Subject: Class 1 Permit Modification Notifications, Waste Isolation Pilot Plant Hazardous Waste Facility Permit Number: NM4890139088-TSDF

**Class 1 Permit Modification Notifications**

**Waste Isolation Pilot Plant  
Carlsbad, New Mexico**

**WIPP Permit Number - NM4890139088-TSDF**

**Figure M-66**  
**WIPP Facility Boundaries Showing 16-square-Mile Land Withdrawal Boundary**

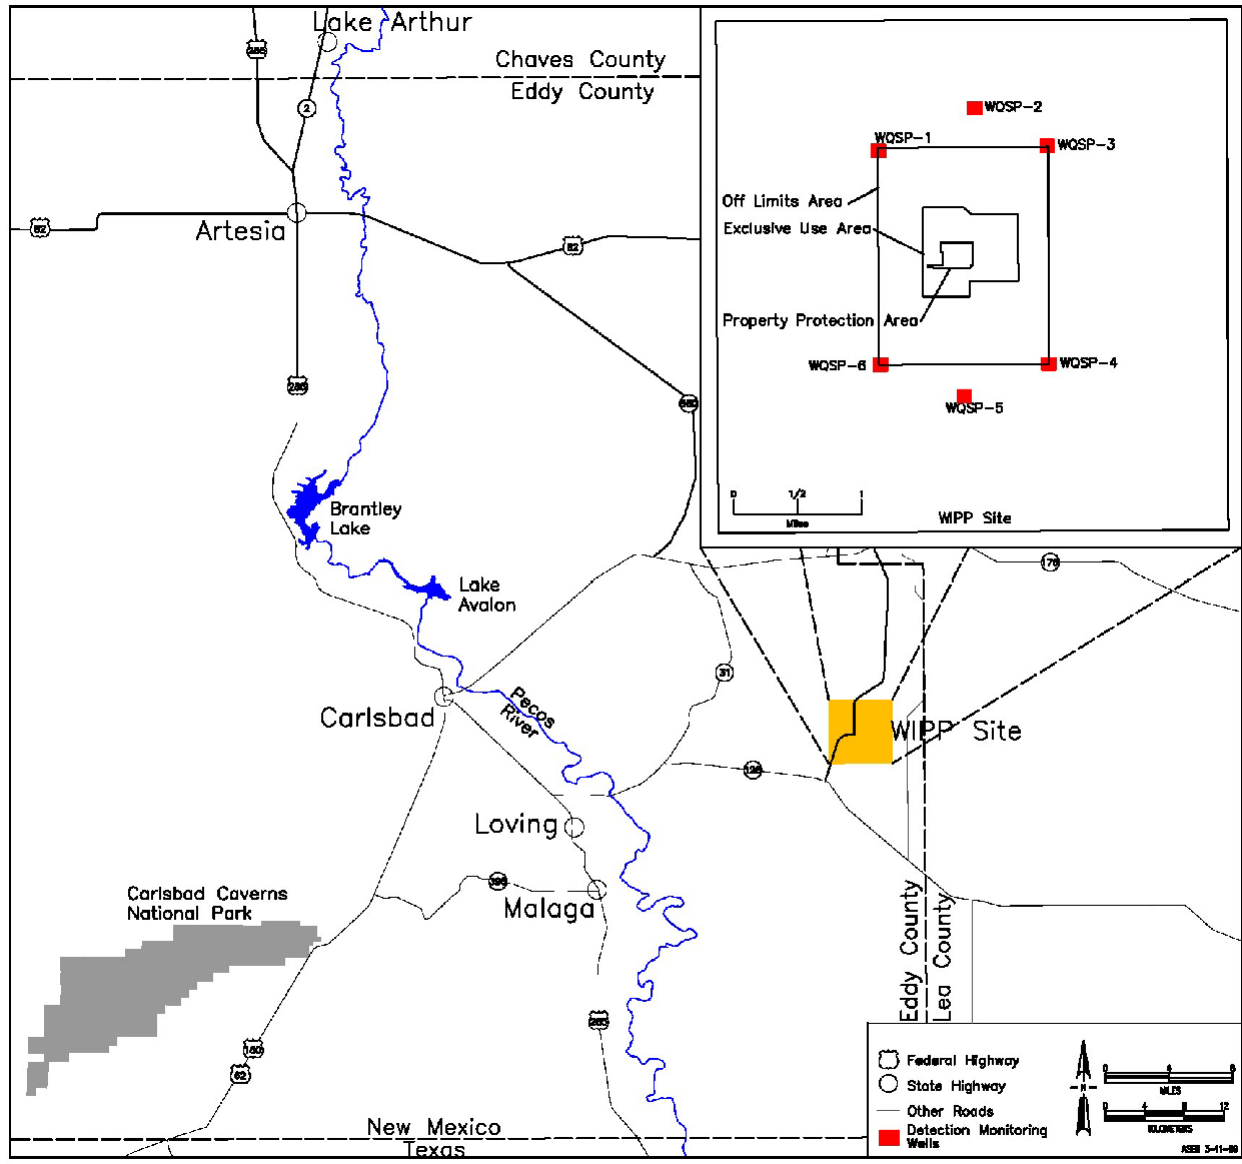
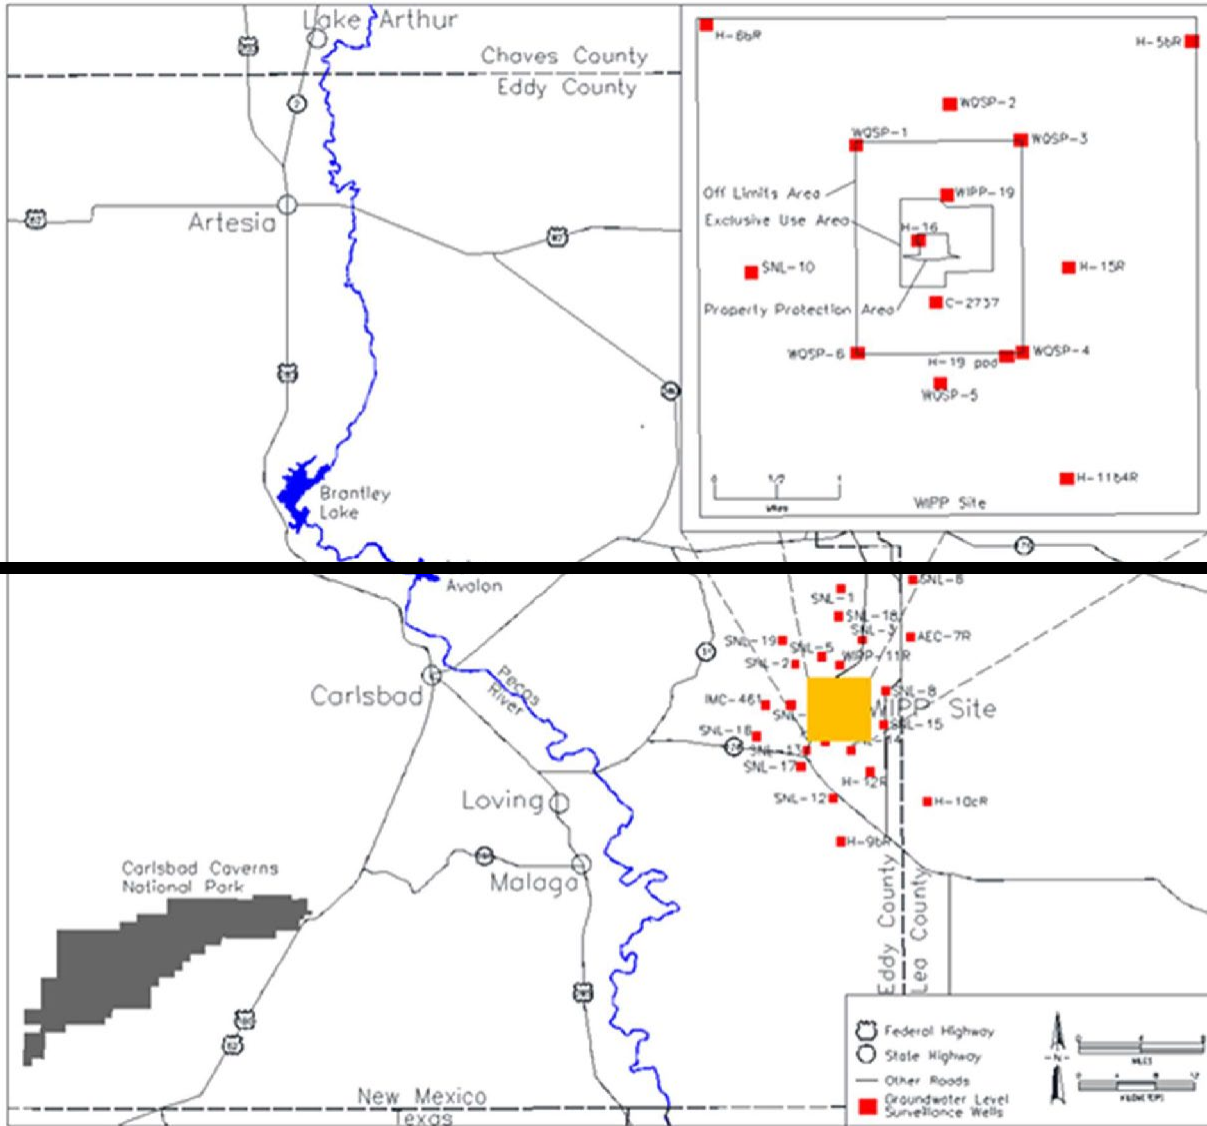
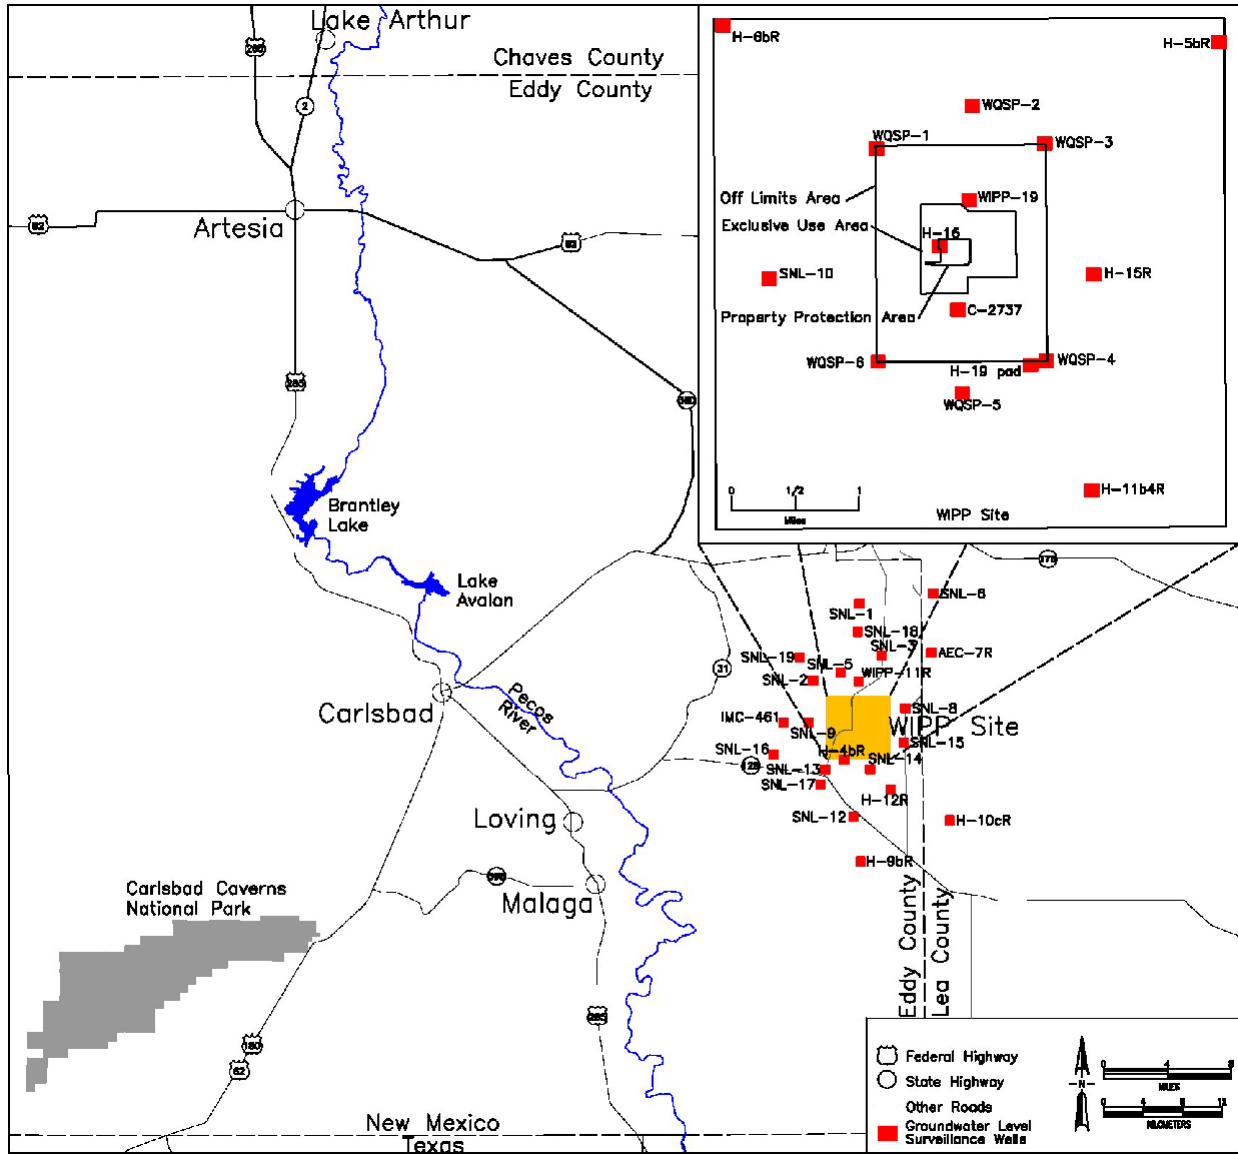
- Figure M-66, *WIPP Facility Boundaries Showing 16-square-Mile Land Withdrawal Boundary*
  - Replaced with a new figure that depicts the updated PPA and nearby public accessible roads.

Permit Attachment B, Figure B2-3, and Permit Attachment M, Figure M-66, have been replaced with a figure that more appropriately depicts the facility boundaries. The railway and private roads have been removed from these figures. The Permittees have no plans to use the railway and removing the private roads ensures that only roads that could be accessed by the public are depicted. These changes are needed to ensure the information in the figures are current and consistent.

**Figure M-70**  
**Detection Monitoring Well Locations**

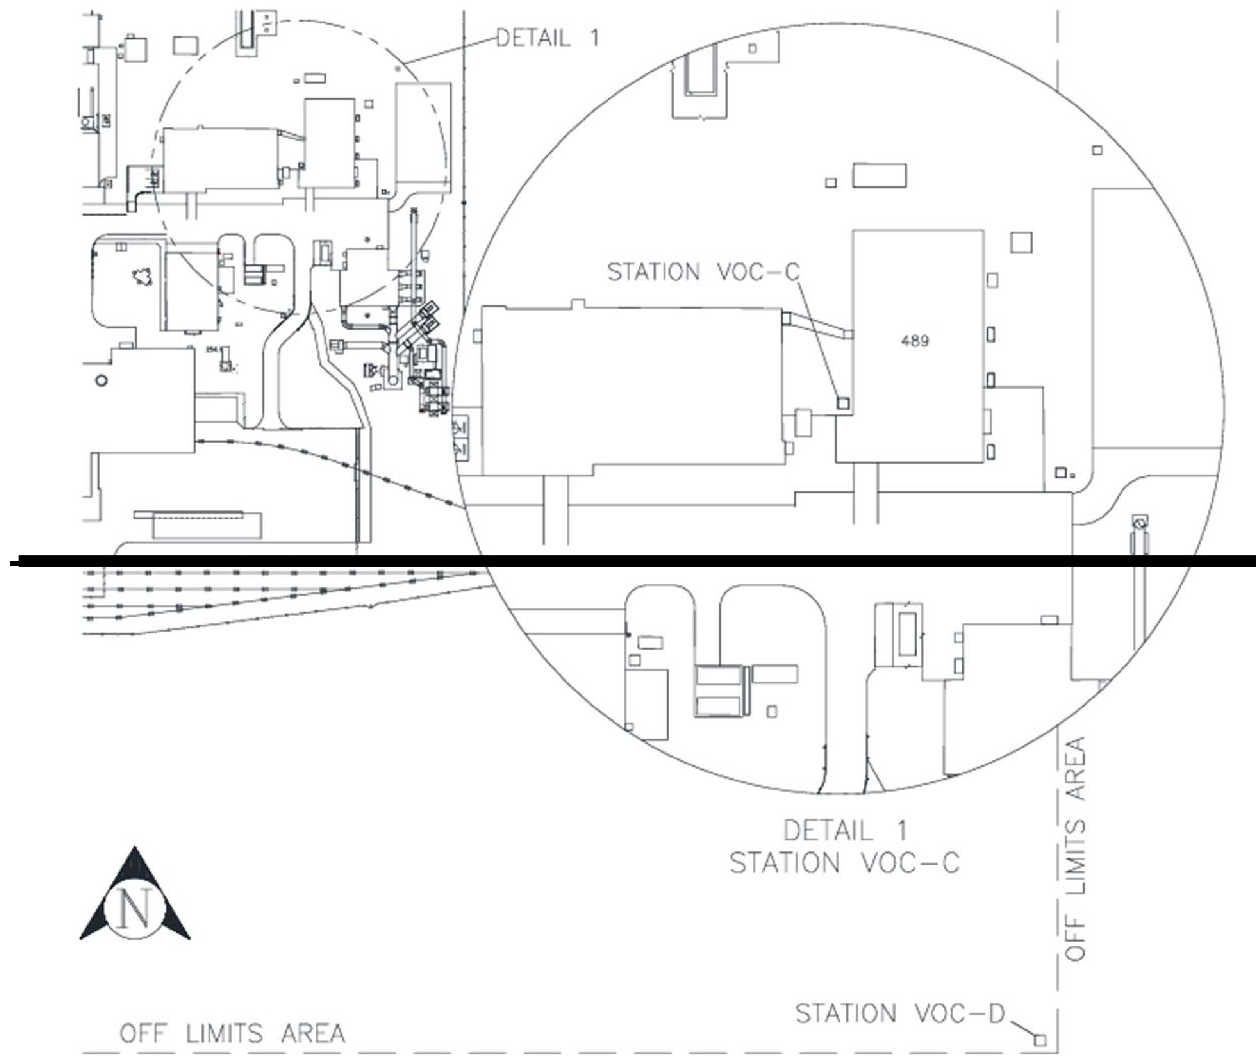
- Figure M-70, *Detection Monitoring Well Locations*
  - Updated the PPA fence line.
- Figure M-77, *Groundwater Level Surveillance Wells (inset represents the Groundwater Level Surveillance Wells within the WIPP Land Withdrawal Area)*

Permit Attachment M, Figures M-70 and M-77 have been updated to show the change to the PPA fence line. Permit Attachment M, Figure M-78, has been updated to remove an outdated reference to Permit Attachment D, Figure D-1a. Figure D-1a was combined with Figure D-1 in the 2020 Renewal Application. In addition, this figure has been updated to remove the rail tracks and the southeast fence line. These changes are needed to update the Permit with the current layout of the facility and to streamline Permit text and figures.

**Figure M-77**  
**Groundwater Level Surveillance Wells**  
 (inset represents the Groundwater Level Surveillance Wells within the WIPP Land Withdrawal Area)

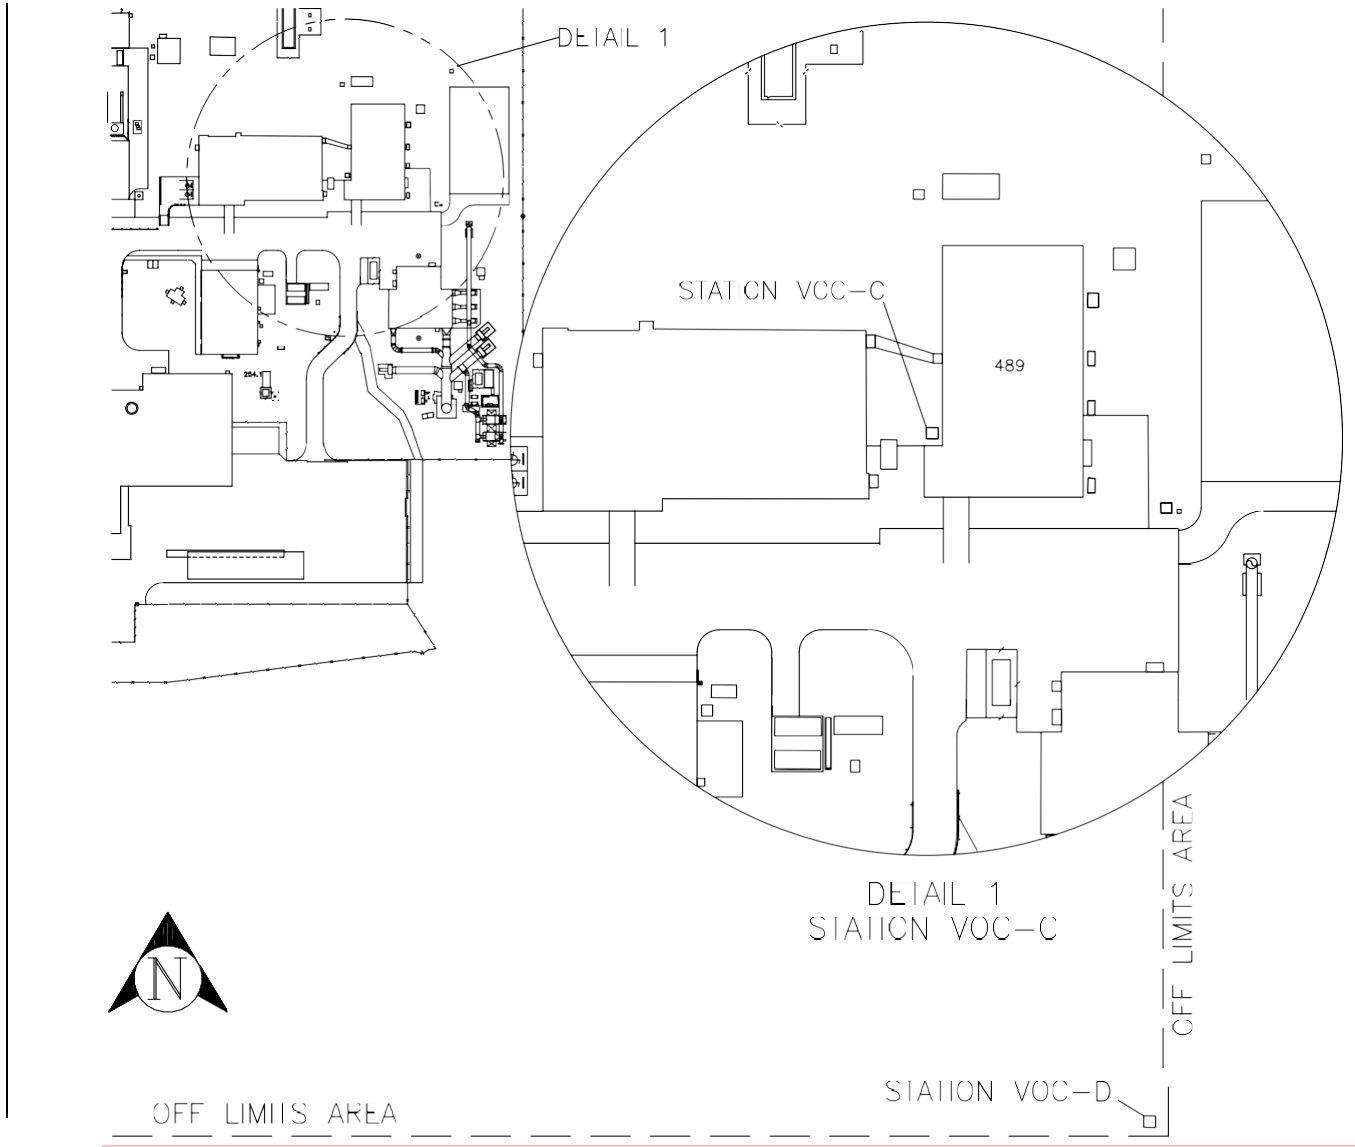
- Updated the PPA fence line.
- Figure M-78, *Repository VOC Monitoring Locations*
  - Deleted “and Figure D-1a.”
  - Removed the rail tracks.
  - Updated the PPA fence line.
